Reactor Oversight Process Task Force FAQ Log
January 12, 2017

Dated February 6, 2017

FAQ 16-04, Browns Ferry Safety System Functional Failure

FAQ 17-01
Grand Gulf June 2016 Power Change

PDS Trend Tool

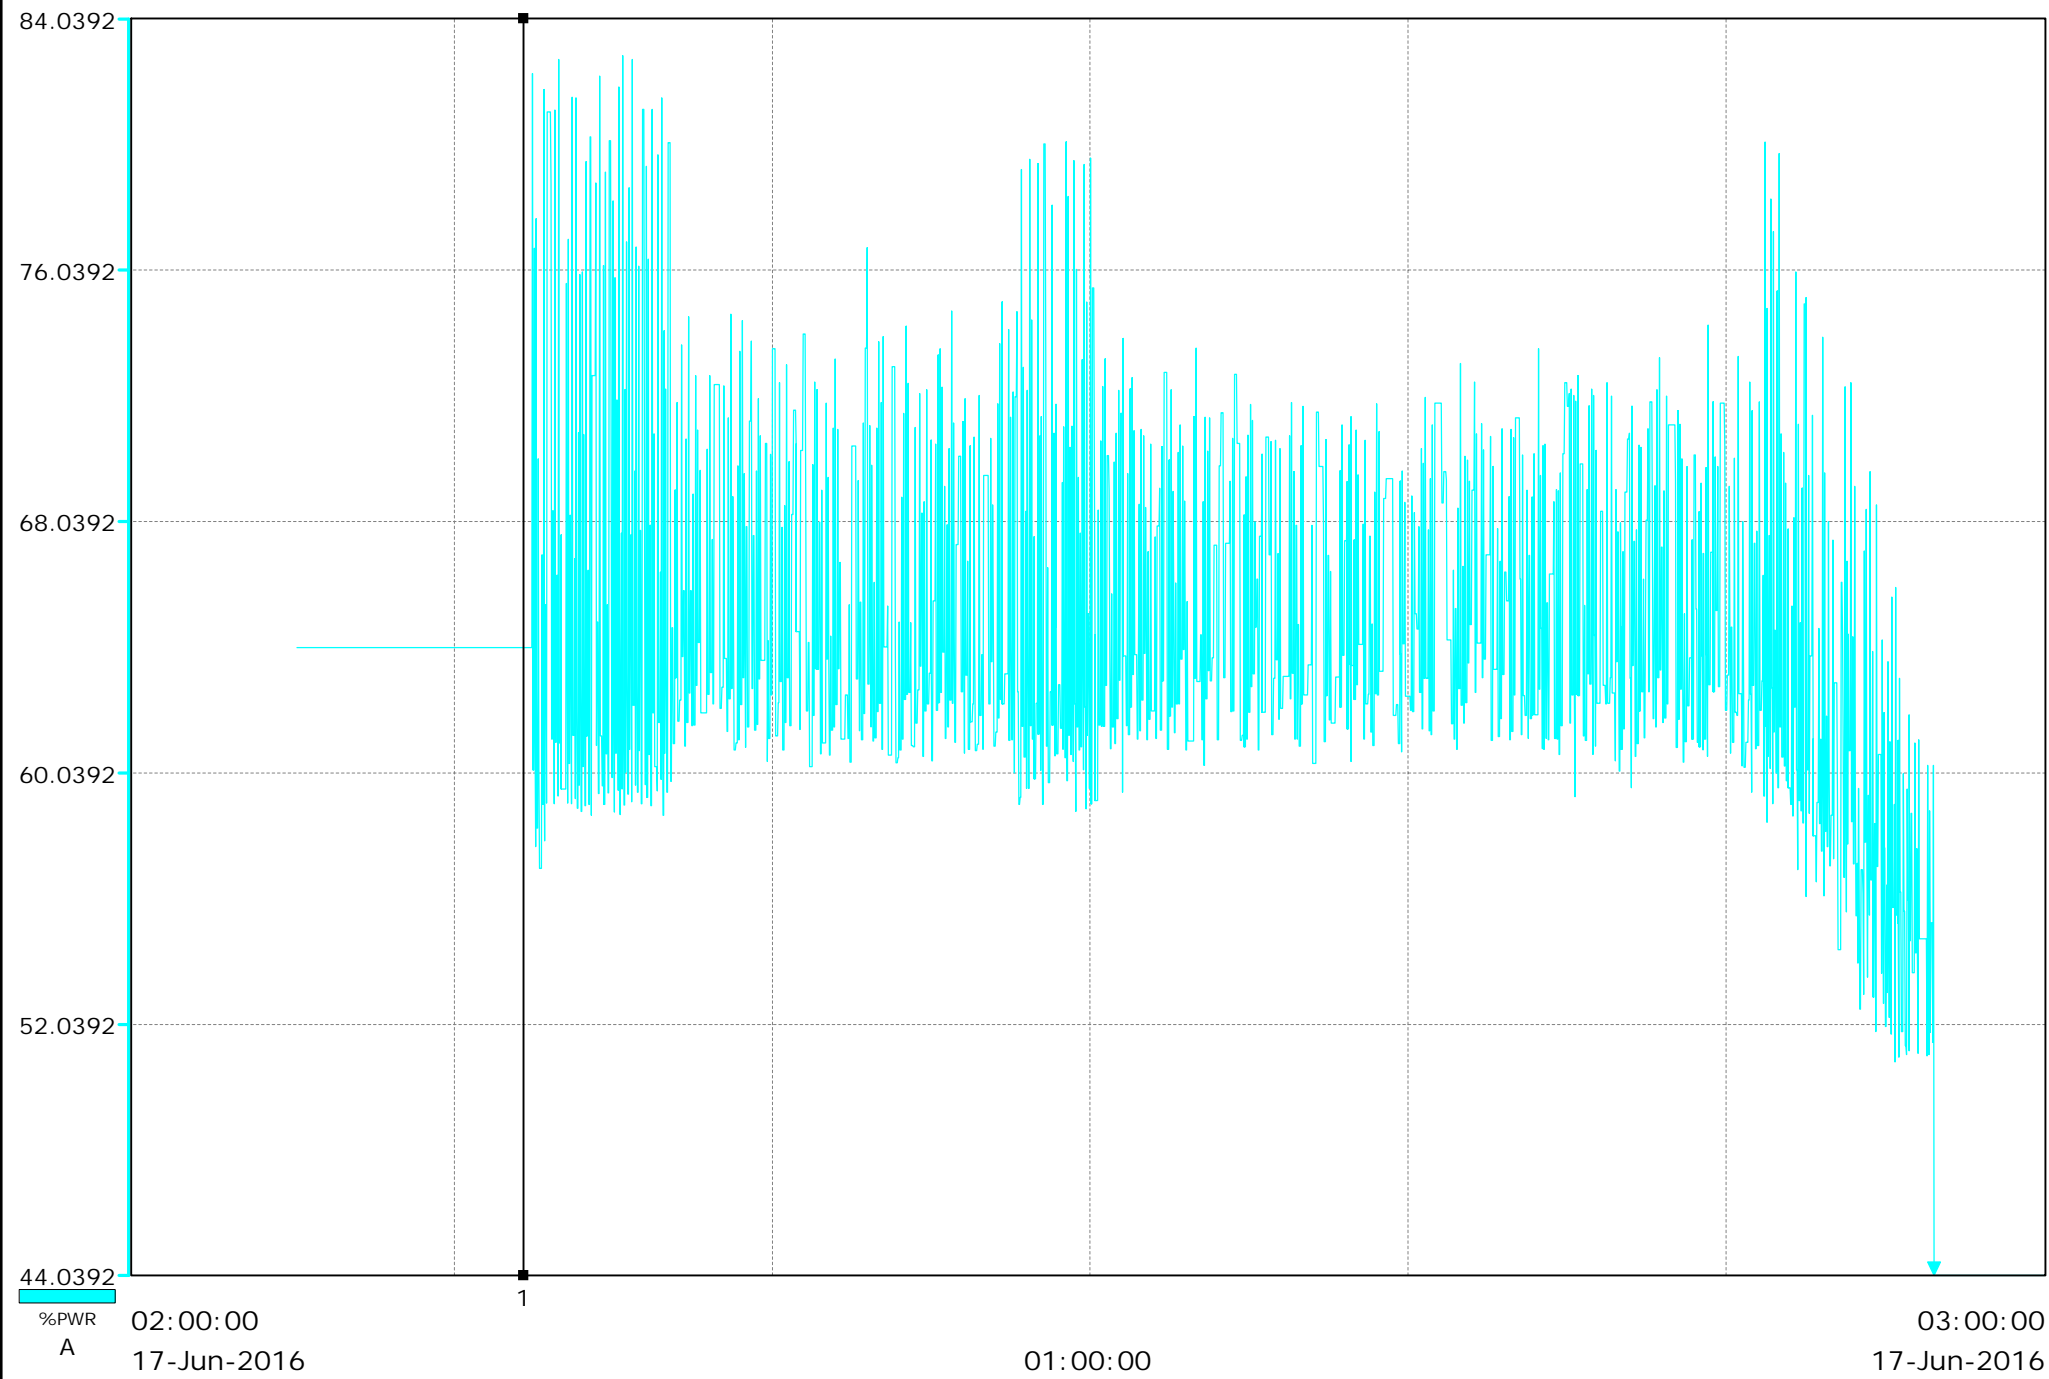
On June 17, 2016 the Grand Gulf Nuclear Station was performing routine Turbine Control Valve testing in accordance with an approved procedure. During this testing the operators depressed the rest button on a solenoid valve to test one turbine control valve closure. The solenoid did not perform as designed

and ultimately a second control valve closed and remaining two control valves began oscillating (open/close) in an attempt to maintain turbine load/power. This oscillation induced a similar power swing in the core. Upon release of the solenoid test switch the oscillations dampened but did not terminate.

The operators next attempted to reopen the first valve in accordance with the test procedure slow-close method using the control oil bleed-off valve. This attempt did not open the valve and two valves remained closed. This increased the magnitude of the oscillations of the remaining two valves. The increased oscillation of the control valves induces a larger power oscillation in the core. Upon closure of the bleed-off valve the oscillations again dampened but did not terminate.

In an attempt to reduce and control the power oscillations within the core the operators inserted a number of control rods several steps. This dampened the magnitude of the power oscillations and frequency time between oscillations. This final action ultimately lead to a OPRM reactor trip.

It is Entergy's position, based on the guidance provided in Lines 1 & 2 on Page 16 of NEI 99-02, that this was one event caused by the unexpected closure of a second control valve. This closure resulted from equipment failure of the solenoid valve, which ultimately was terminated by the insertion of rods and the receipt of an OPRM reactor trip. Operator actions to attempt to open the first closed valve using the test procedure, and reduce power changed the magnitude and frequency of the power oscillations but could not in of themselves cause the oscillations without the second control valve being shut. Therefore this should be counted as an unplanned SCRAM.

- A Graph showing the power oscillations. The graph depicts magnitude of the y-axes and the time on the x-axes.

The NRC inspectors at the Grand Gulf Nuclear Station, however, do not agree with the licensee's determination that this event is only counted in the Unplanned Scrams per 7000 Critical Hours performance indicator. The NRC inspectors' position is that NEI 99-02, Revision 7, guidance would cause the licensee to count this series of events in both the Unplanned Scram, per 7000 Critical Hours and Unplanned Power Changes per 7000 Critical Hours performance indicators:

The first set of oscillations greater than 20 percent power resulted from the second control valve closure and operator action to maintain the manual push buttons depressed on the solenoid valves. The control rooms' decision to hold the manual push button on the solenoid valve depressed resulted in approximately five minutes, of power oscillations of greater than 20 percent power. When the manual push button on the solenoid valve was depressed, the operators were unknowingly diverting electrohydraulic system flow, which challenged the control valves ability to stabilize steam flow when

two stop valves were closed. Operators then decided to release the manual push buttons and the power oscillations reduced to approximately 10 percent. This response demonstrated that the second control valve closure and the pressure control system issue resulted in power oscillations that were limited to only 10 percent. The operator actions to maintain the manual push button depressed caused power oscillations that were greater than 20 percent power.

The second set of power oscillations of greater than 20 percent was caused by operator actions to troubleshoot the issue by attempting to reset and reopen a control valve using the slow closure method with a different solenoid valve. When the desired plant response was not achieved; operators backed out of the troubleshooting efforts, and the power oscillations returned to approximately 10 percent. The third set of increased power oscillations was caused by additional operator actions as attempts were made to troubleshoot the issue by resetting the control valve. These troubleshooting efforts resulted in additional power oscillations of greater than 20 percent. During the control valve reset, operators began to insert control rods with the intention to reduce power and stop the power oscillations. Operators believed that a power reduction to less than 50 percent power would stabilize the plant since two open control valves could pass the resultant steam produced.

Ultimately, operators inserted four control rods, which reduced power and increased the frequency of the power oscillations: Although the magnitude of the power oscillations decreased, the increased frequency of the power oscillations were now in the "counting domain" of the Oscillating Power Range Monitor system, and provided a valid input to the reactor protection system to cause an automatic reactor SCRAM.

Based on the above information and NEI 99-02, Revision 7, the inspectors' position is that the initial cause of the event (an unexpected control valve closure resulting in 10 percent power oscillations) was not the cause of the automatic reactor SCRAM. The reactor SCRAM was a result of operator action to insert control rods as an attempt to reduce power. Also, the cause of the greater than 20 percent power oscillations was a result of repeated operator decisions and actions to conduct troubleshooting activities during a 42 minute period. Therefore; this series of events should be counted in both the Unplanned Scrams per 7000 Critical Hours and Unplanned Power Changes per 7000 Critical Hours performance indicators.

This even should be counted as an unplanned SCRAM. The cause of the power oscillation and ultimately the reactor SCRAM were the same, the unanticipated closure of the second control valve. The conduct of turbine control valve testing in accordance with approved testing procedures combined with an unexpected equipment failure caused the SCRAM.
